JACK LONDON
PARK
PARTNERS

Re: Notice of Preparation for the Eldridge Renewal Project at the Sonoma Developmental Center

Exhibit 2: High-level summary of potential Project impacts and appropriate alternatives

Figure 21a and 21b. These maps try to “filter out” longer distance movements seen in Figure 20, and focus on shorter animal movements that have a higher locational accuracy. *Data Credit:* Audubon Canyon Ranch, and True Wild.

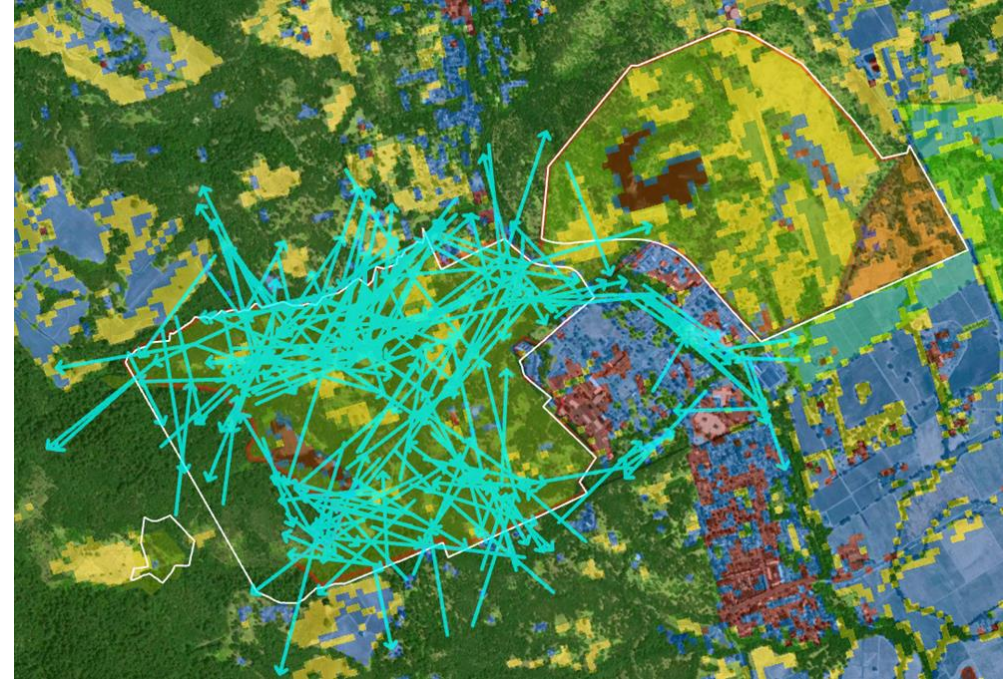
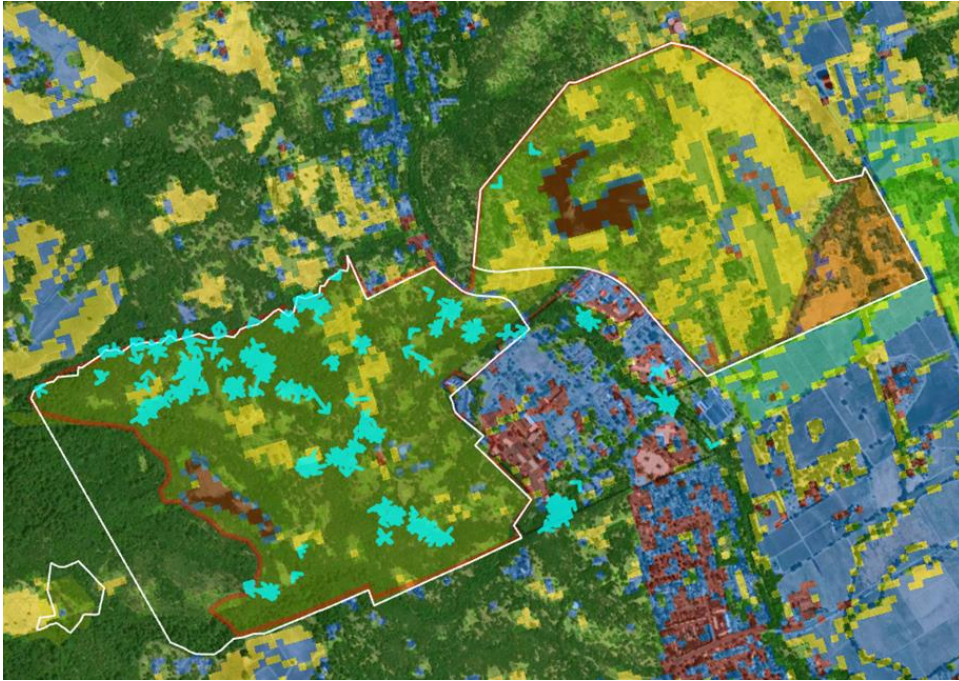
- Mountain lions are commonly utilizing SDC lands, for both feeding and movement.
- Lions seem to prefer Sonoma Creek and Mill Creek when moving through the developed portion of the SDC.

To avoid impacts to mountain lion movement, the Project must consider alternative design measures for the design and layout of riparian setbacks as described in the alternatives above.

Figure 22. Design elements that might be incorporated into a riparian buffer design that protects wildlife connectivity, incorporates stormwater management, defines the area of public use, and provides community and land value benefits from a pathway or linear parks.

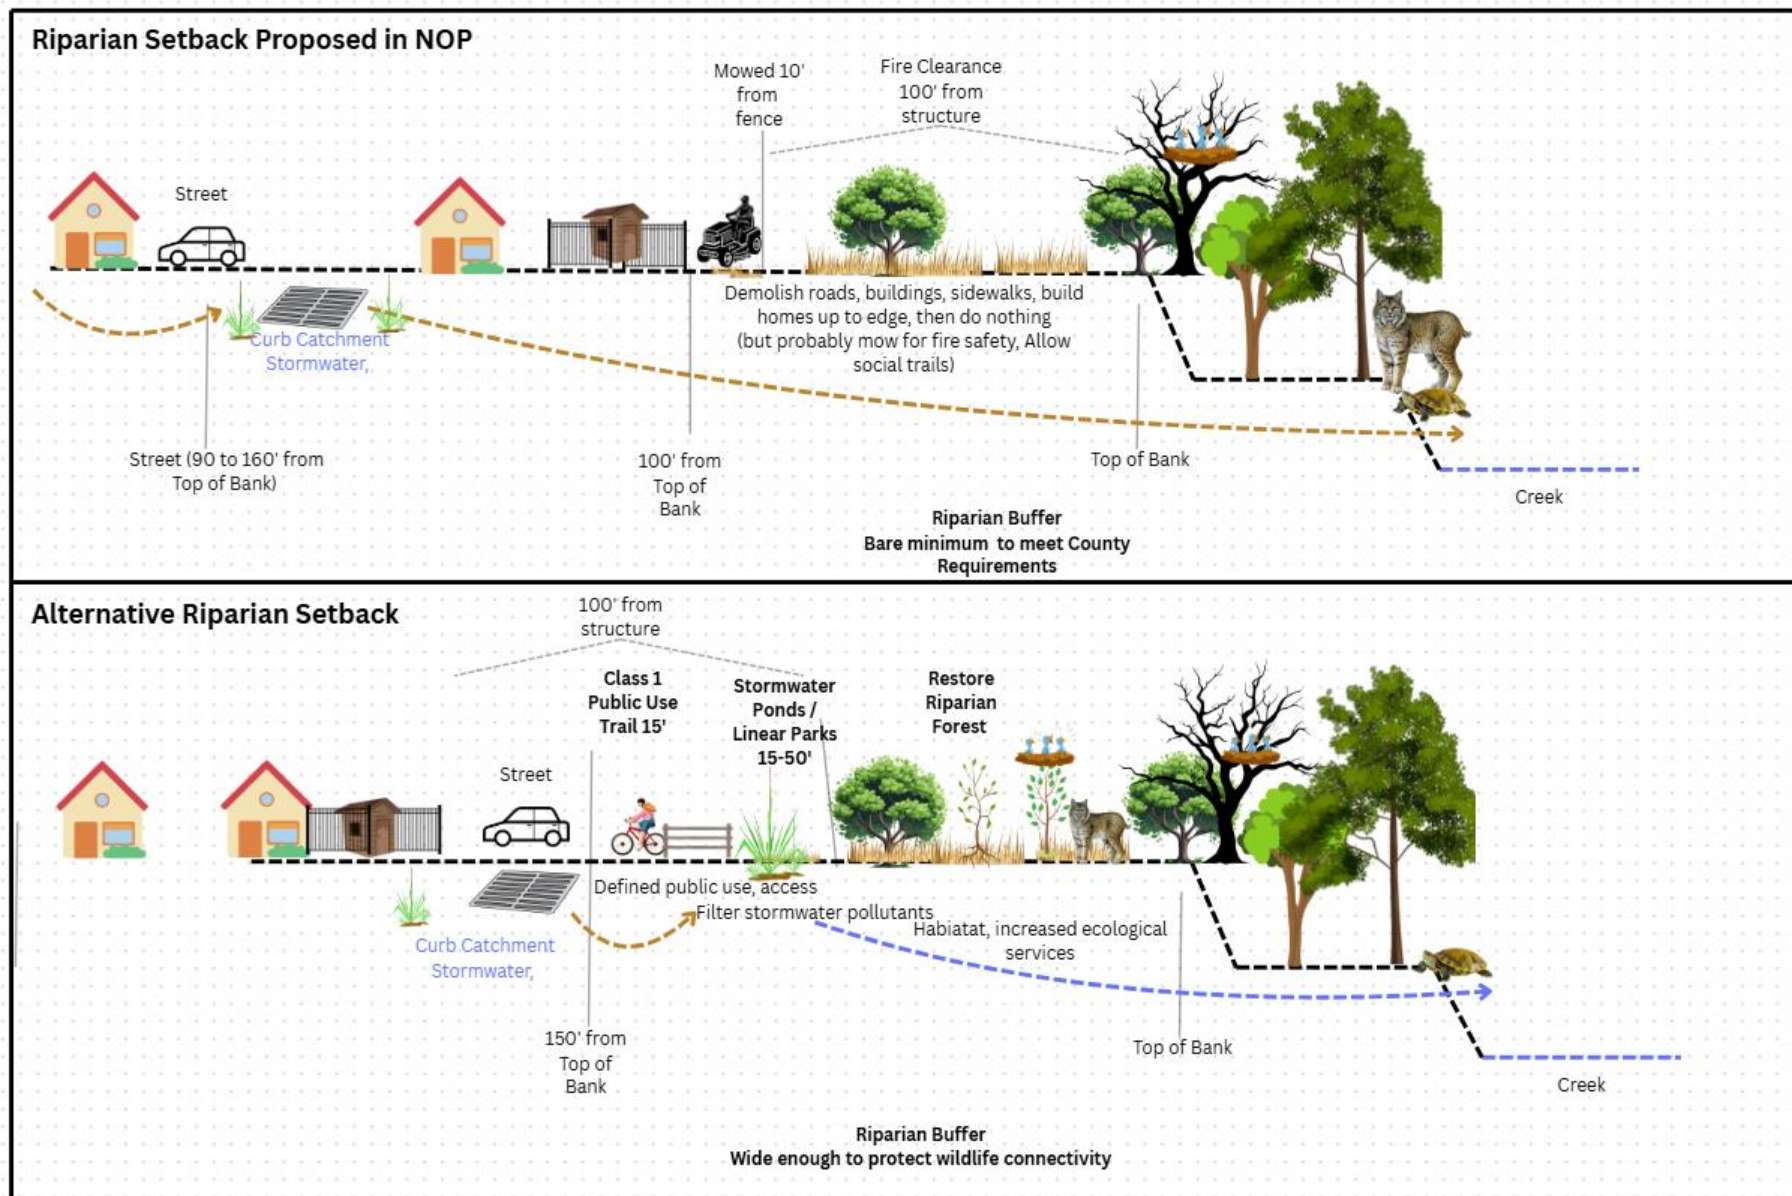
A re-designed riparian setback and interface with proposed construction to avoid impacts to wildlife connectivity and special species habitat, and provide additional economic and community benefits. See Figure 22, Exhibit 3 for a mockup.

- Habitat restoration (0-50’ from Top of Bank, along Sonoma Creek)
 - Stormwater features and habitat restoration (50’-100’)
 - Trails or sidewalks that provide public opportunities for recreation, versus informal recreation in setbacks behind backyards (100-175’, width varies)

- Tightly defined zones of public use, using visual barriers and plantings to discourage social use of wildlife corridors and decrease sight-lines to wildlife (100’)

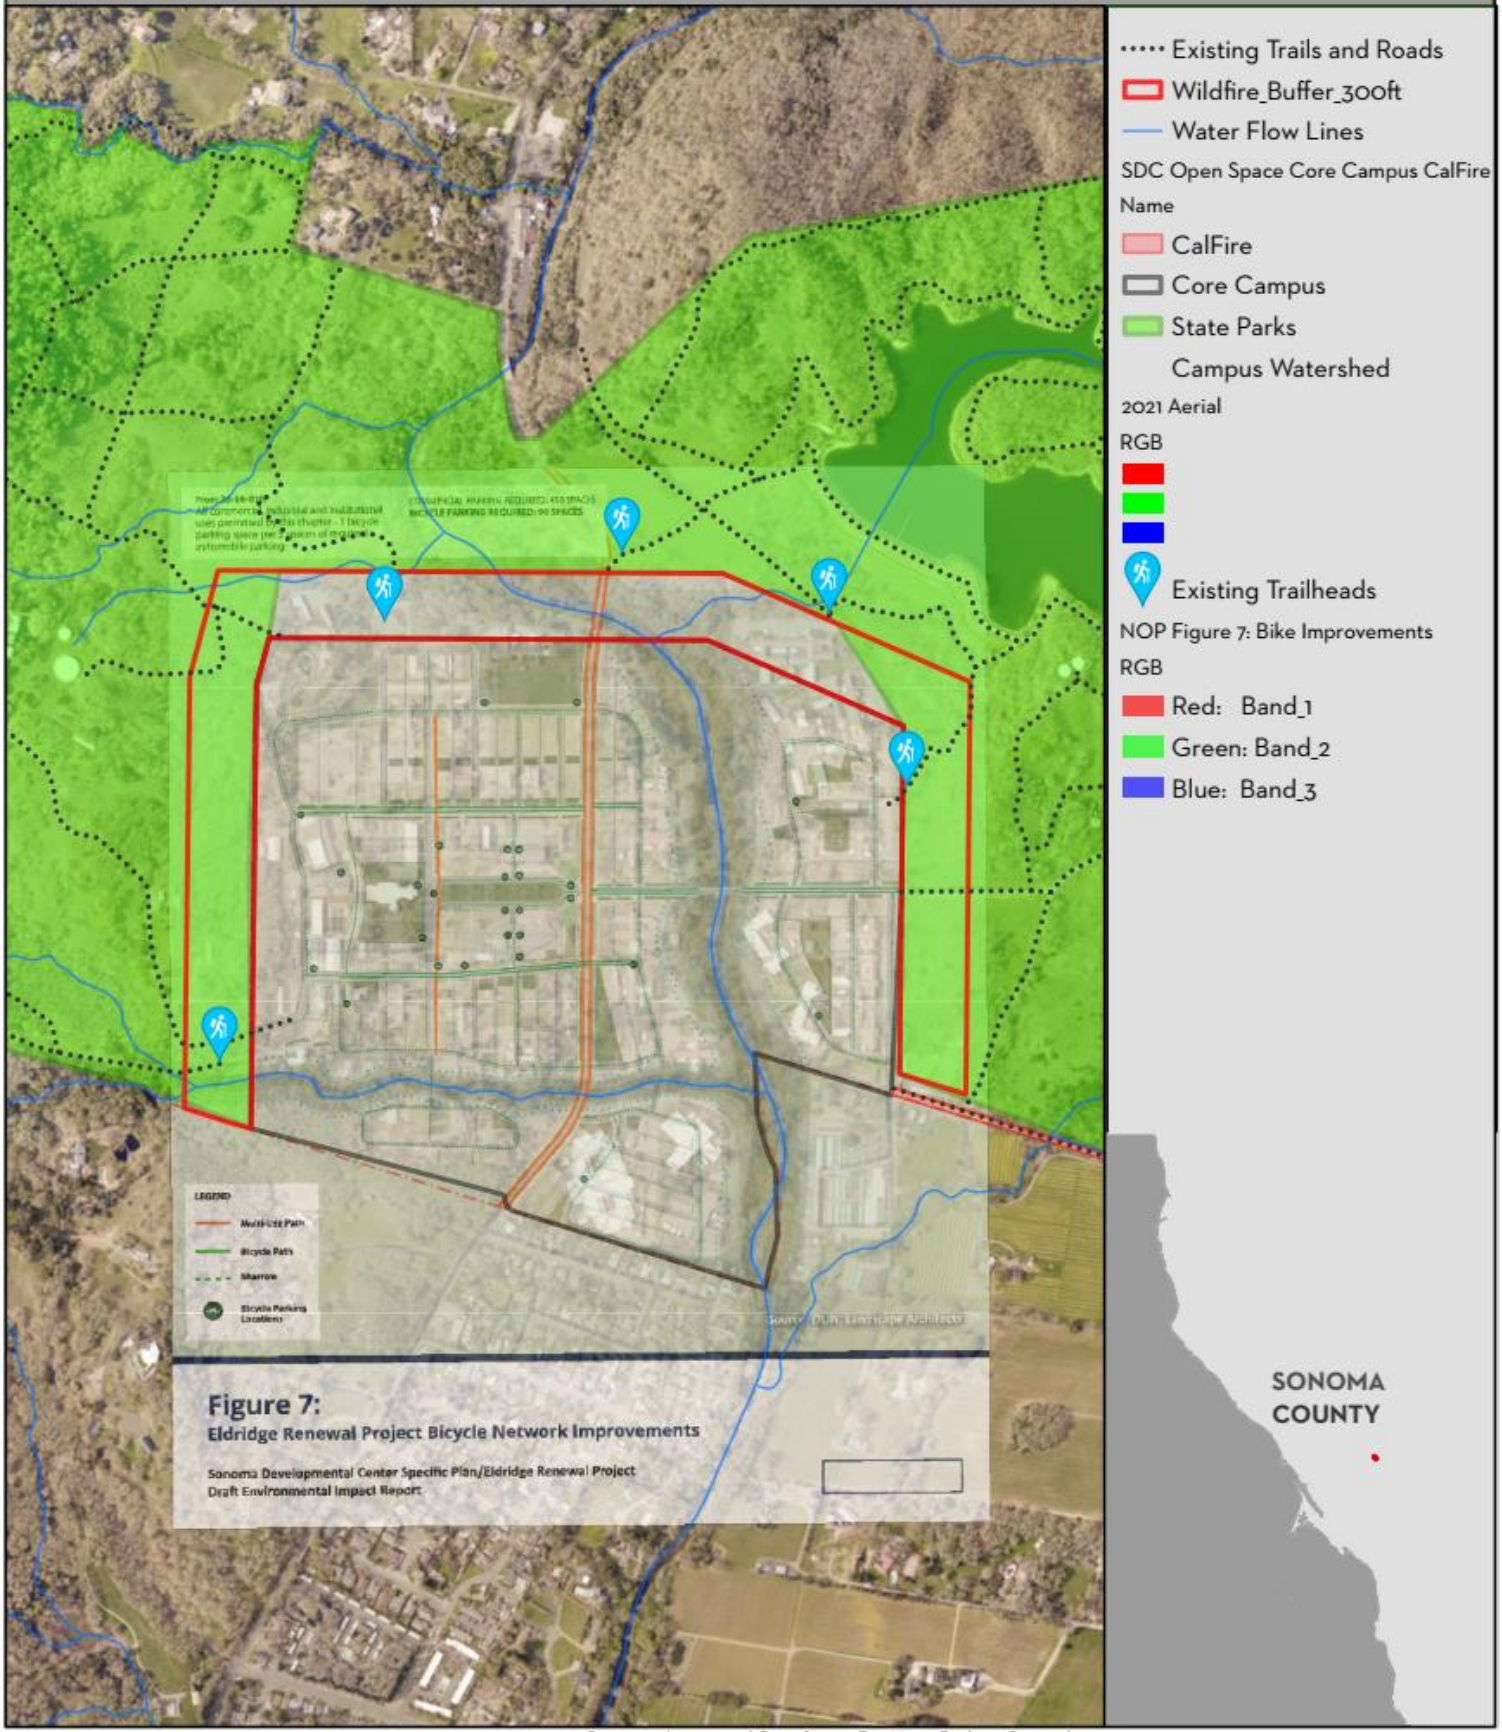
The NOP makes no reference to the fact that the Project site controls access to SDC Open Space lands located to both sides of the Project. This approach conflicts with many goals listed in the NOP. If the Plan or Project do not take certain actions, there is likely to be Project impacts on recreation, as well as on wildlife, and fire risk due to recreation by Project residents. See Figure 23, Exhibit 3 **State Parks**

- Describe impacts of 3000 additional people on recreational and natural resources on SDC Open Space and Sonoma County Regional Parks, describing changes in fire ignition risk, use of social trails, issues with parking, and incompatible uses by Project residents or visitors with existing Parks management plans; or
- Add design features or mitigation measures listed in the following Section 3.

Figure 24. 2025 Fire Hazard Severity Zones in relation to the SDC. Source: CAL FIRE. SDC lands are shown in black outline . LRAs are shown with a grey outline.

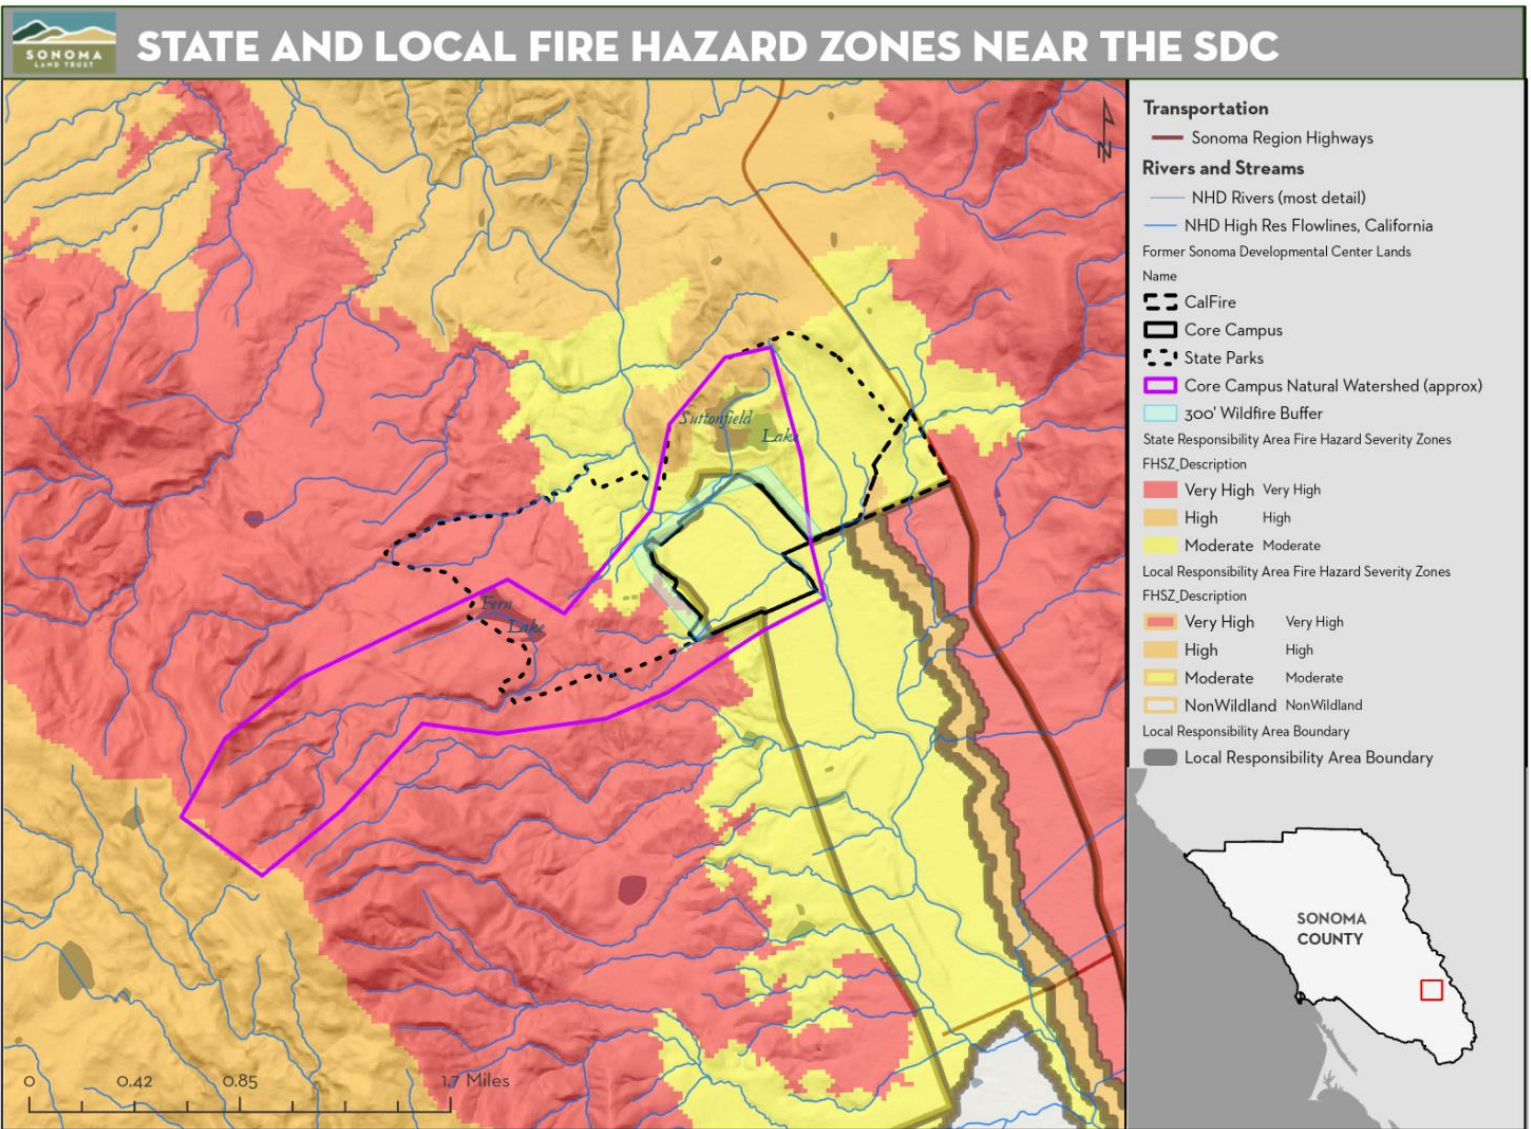
Not shown: The Project proposes to use surface waters (Roulette Springs, Fern Lake, Suttonfield Lake, Mill Creek, Asbury Creek) for campus water supply.

Conclusions: **1)** The Project is *near* Very High Fire Hazard Severity Zones, and most of the campus water supply is *within* a Very High Fire Hazard Severity Zone. **2)** Portions of Campus and Wildfire buffer zone are in the State Responsibility Area.

Figure 25. California Department of Conservation data related to post-fire landslide susceptibility. White to red colors show susceptibility to “deep seated landslides” based on rock strength and slope. ?? marks show geographic features that have been mapped as potential historical landslides.

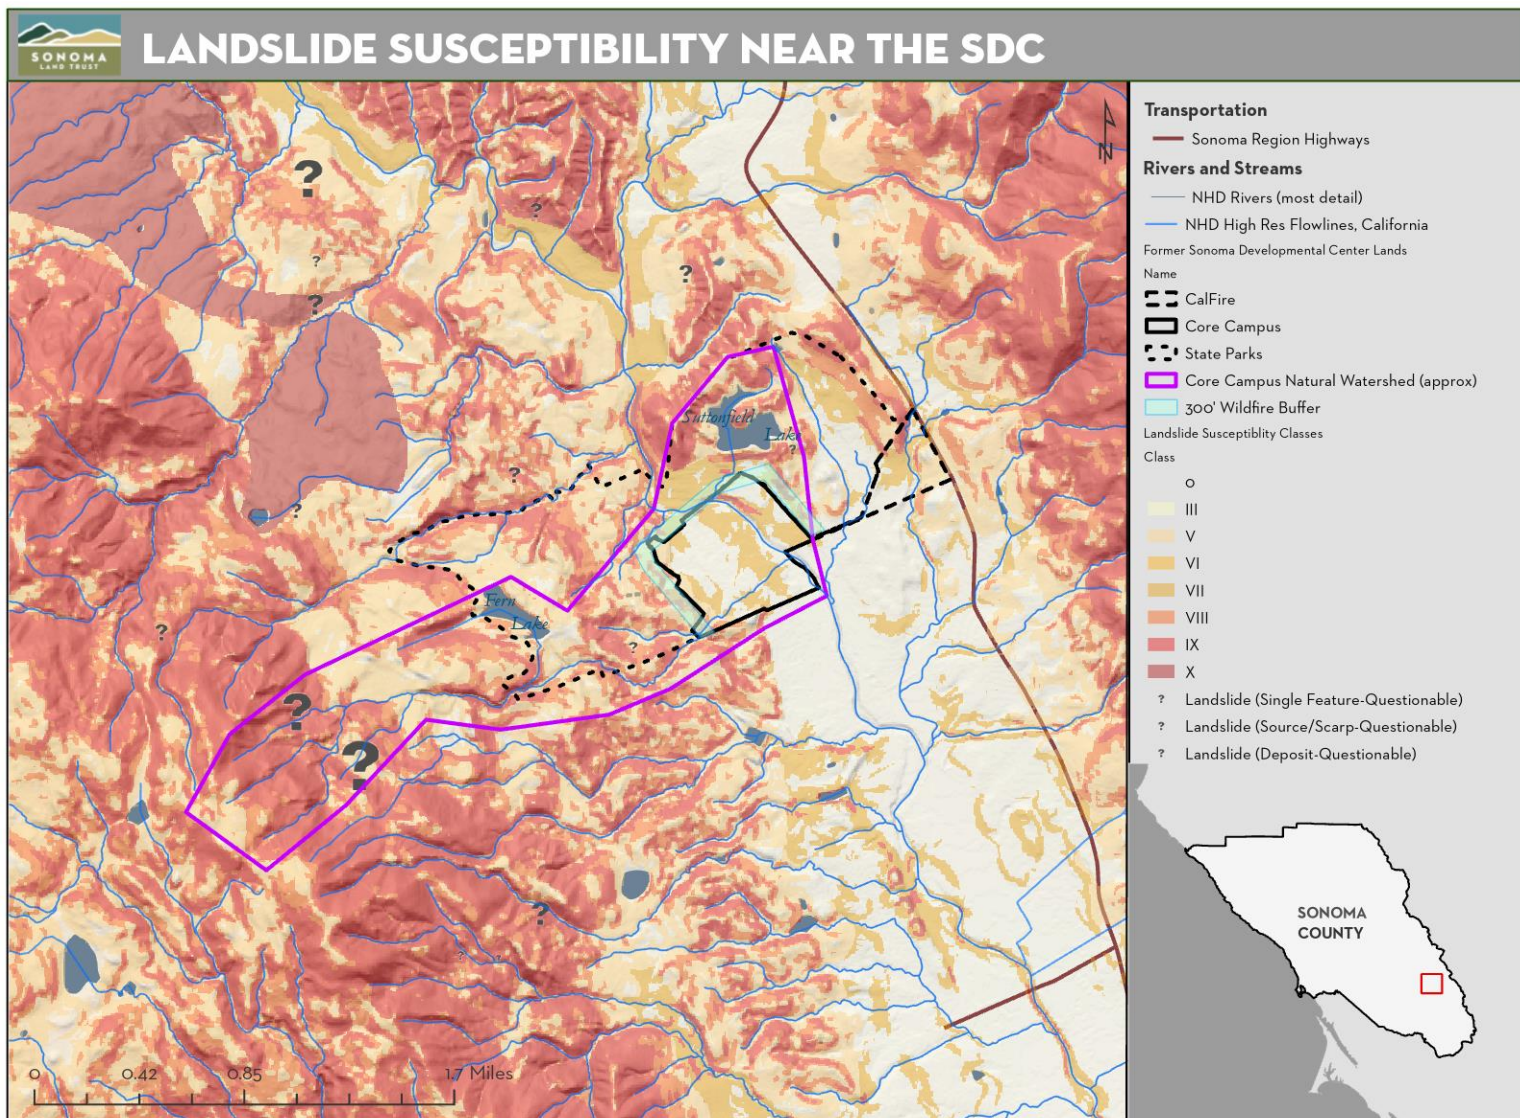
Conclusion: The upper headwaters of Mill and Asbury Creeks have significant risk of post-fire landslides or debris flows, that must be explored in more detail. Similarly, geologic risk to the Lake Suttonfield dam should be examined (Suttonfield Dam condition was rated as “fair” in 2025).

- Evaluate post-fire hazards, then develop emergency plans or avoidance measures that could include:
 - Evaluate potential for post-fire debris flows originating in the headwaters of Mill Creek, and the exposure of proposed development to such occurrences
